Subject ▶ Change of Motor sleeve, Stem adapter

For Models ▶ GN900

Description ▶ Motor sleeve and Stem adapter have been changed for standardization.

- ① Change of Motor sleeve
• Five ribs have been added.

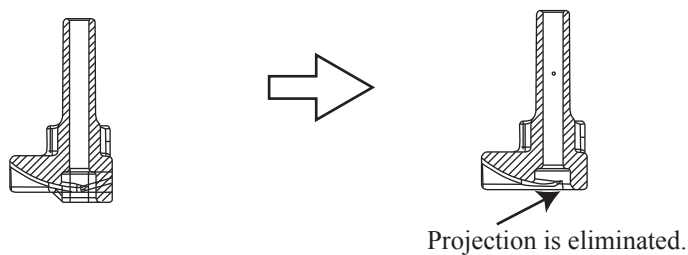
- ② Change of Stem adapter
• Projection has been eliminated.

Item No.	Current part		Q'ty	I/C	New part		Q'ty	Note
①	037	Motor sleeve 450737-3		1	Yes	Motor sleeve 454002-2		1	
②	051	Stem adapter 450731-5		1	Yes	Stem adapter 454003-0		1
